Subject: **Request for Modification of the Section 401 Water Quality Certification**
for the proposed replacement of Bridge No. 148 over Lamance Creek on SR
1326 in Transylvania County, Federal Aid Project No. BRZ-1326(3);
Division 14; TIP No. B-4989. Debit \$240.00, WBS 40461.1.1

Subject: **Addendum to the Application for Section 404 Regional General Permit 198200031 and Section 401 Water Quality Certification** for the proposed replacement of Bridge No. 148 over Lamance Creek on SR 1326 in Transylvania County, Federal Aid Project No. BRZ-1326(3); Division 14; TIP No. B-4989.

PERMIT DRAWINGS SURFACE WATER & WETLAND IMPACTS

Permit Drawing
Sheet 4 of 10

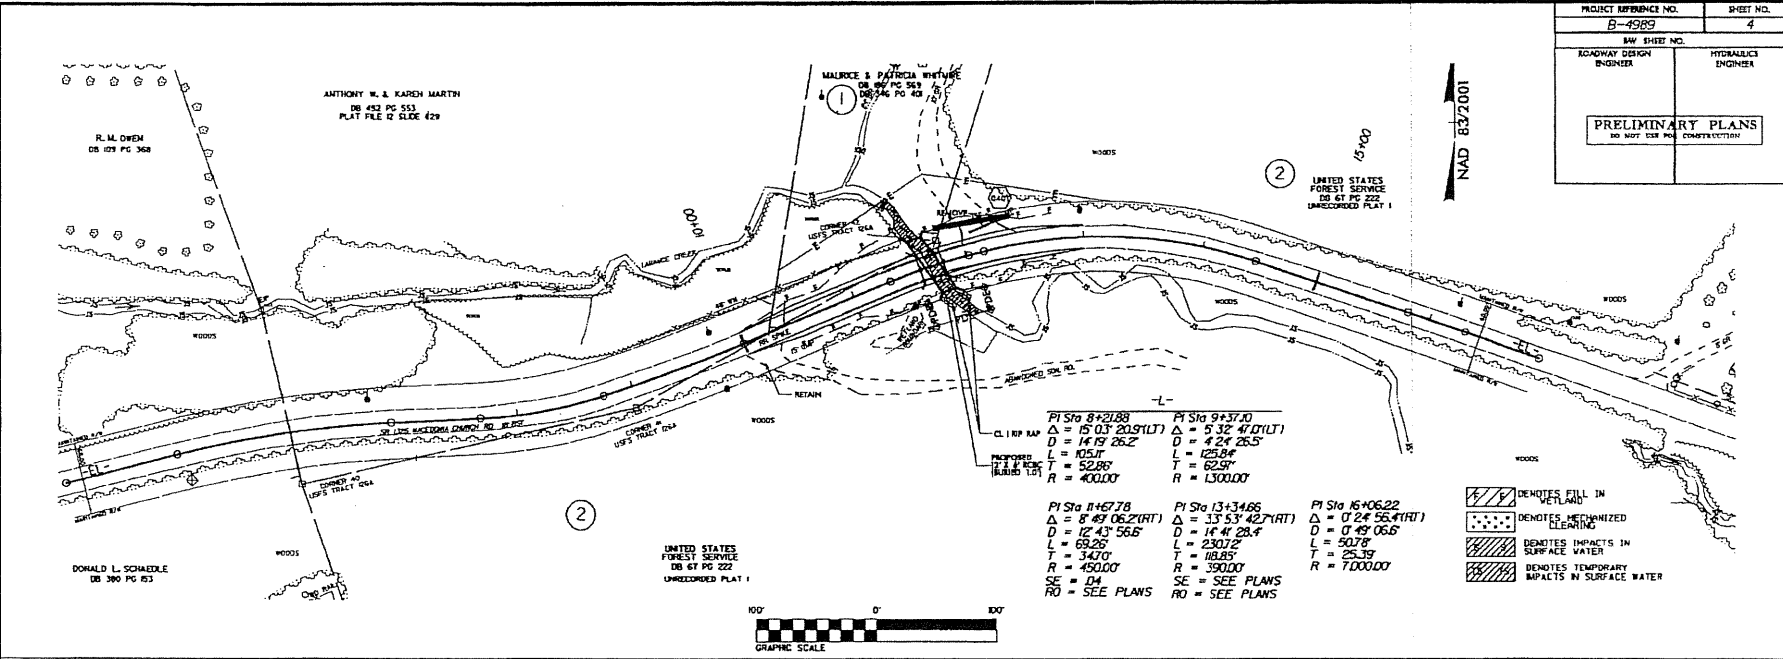
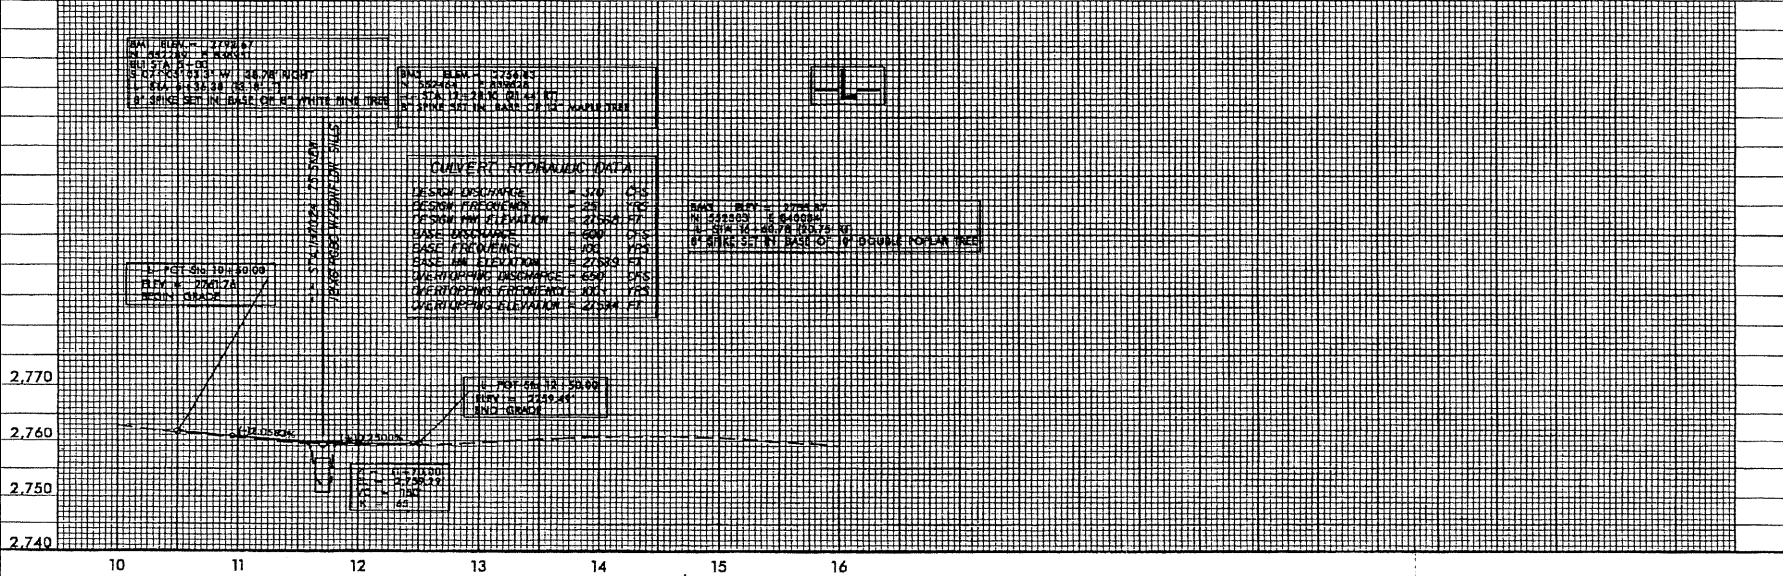
This 401 permit modification request is to update the permanent impacts to Lamance Creek and include the avoidance minimization measures that will be required for this project. The previous permit application and subsequent 401 permit listed the impacts incorrectly as 33 linear feet of impacts from the culvert and 17 feet of impact from bank stabilization. The corrected impacts are 53 linear feet for the culvert placement and 20 linear feet for bank stabilization.

- 404 application addendum sent to USACE November 8, 2011
- Revised permit drawings showing the impacts of 53 feet for the culvert and 20 feet for bank stabilization (previous application had 33 feet for the culvert and 17 feet for bank stabilization)
- Revised EEP acceptance
- Section 404 Permit from USACE
- GP31 Conditions
